**Notice of Availability of Final Records of Decision
for Four Environmental Sites
Longhorn Army Ammunition Plant, Karnack, Texas**

The United States Army announces three Record of Decision (ROD) documents for environmental sites at Longhorn Army Ammunition Plant. The RODs, which document the selected remedies for the sites, have been signed by the U.S. Army and the U.S. Environmental Protection Agency and have the concurrence of the Texas Commission on Environmental Quality as follows:

LHAAP-16

LHAAP-17

Most Recent TCE Concentrations in Shallow Zone Monitor Wells

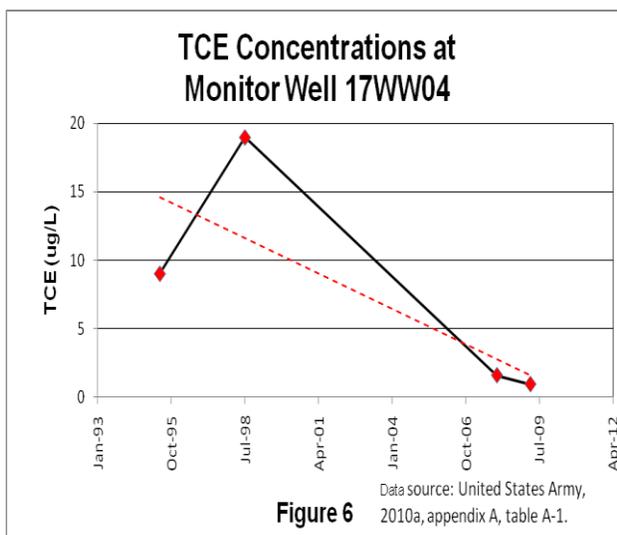
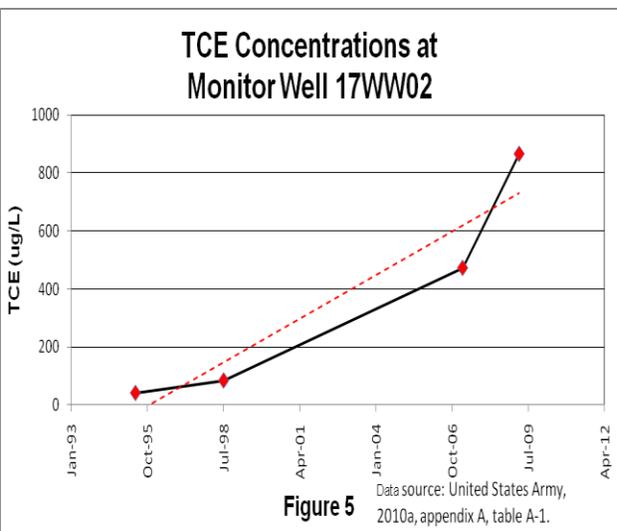
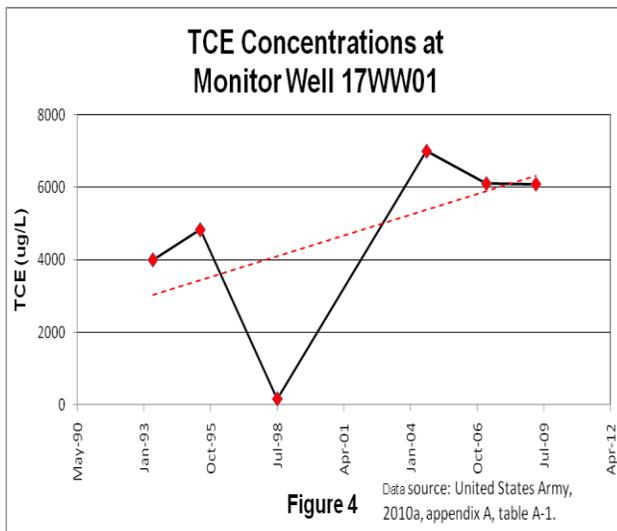
Question/comment: TCE samples have been collected from 11 monitor wells in the shallow zone. TCE concentrations have exceeded the 5 µg/L MCL in six of these wells. Of these six wells TCE concentrations are rising in four, and dropping in two (see figures 1b, 2b, 3b, 4, 5, and 6). The table below shows the most recent TCE concentrations found in the six wells.

Clearly, natural attenuation is not acting to reduce TCE concentrations throughout the site. Although the Army claims that high concentrations of perchlorate are inhibiting the attenuation of TCE, this assertion is not supported by the data (see first comment). The Army should reevaluate its reliance on natural attenuation to reduce TCE concentrations at Site 17.

Response: The most significant increase in TCE concentrations is seen at well 17WW01 between 1998 and 2004. TCE concentrations have declined in this well since 2004. Increases in TCE concentrations at wells 130, 17WW02, and 17WW03 are not as significant and may reflect seasonal variations instead of an overall increase in mass. The groundwater gradient at LHAAP-17 is fairly flat and the diffusion of TCE away from 17WW01 may cause a rise in concentrations in the surrounding wells (i.e., 17WW02 and 17WW03). Even though there are fluctuations in the wells at LHAAP-17, the plume is bounded and there does not appear to be a significant migration of the plume. Additionally, pump and treat will contain the plume and will reduce TCE concentrations (prior to MNA evaluation) as well as the perchlorate.

Under current conditions at LHAAP-17, with the addition of perchlorate from contaminated soil by percolation, natural attenuation cannot be effectively evaluated since the high perchlorate concentrations are inhibiting TCE attenuation. After contaminated soil is removed, groundwater pumping will still disturb natural conditions. It is only after soil is removed and pumping is stopped that an effective MNA evaluation may be made. When that evaluation is complete, and if it is favorable, MNA will continue as the remedy. However, if the evaluation is not favorable, another remedy (e.g., in situ bioremediation) will be implemented to reduce the TCE concentrations.

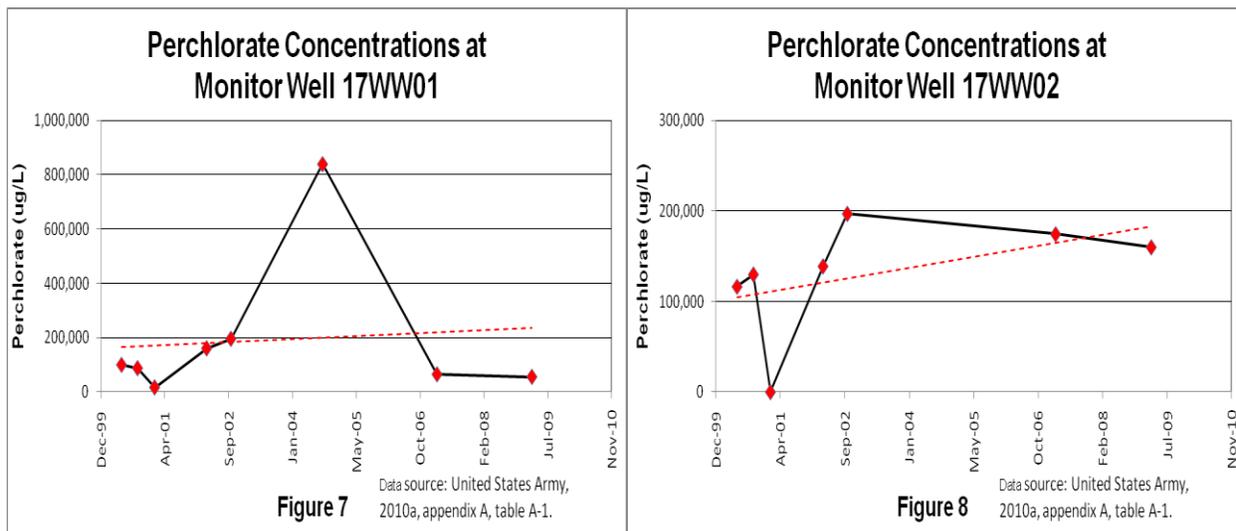
Question/comment: The clean-up time estimate is based on data from monitor well 17WW06, where TCE concentrations are declining (see figure 3b). However, this estimate does not apply to those portions of Site 17 where TCE concentrations are increasing (see third comment). The Army should provide an estimate of clean-up time for the entire site.

Response: Although there is some uncertainty associated with the cleanup time for the entire site because of the inhibitive effects of perchlorate, the data collected during the two year period of natural attenuation monitoring (post pump and treat) will be used to remove some of the uncertainties associated with the estimate of time to achieve MCLs. The statutory five-year reviews will evaluate the effectiveness of the remedy and estimated durations to reach MCLs and would recommend implementation of other measures if needed.
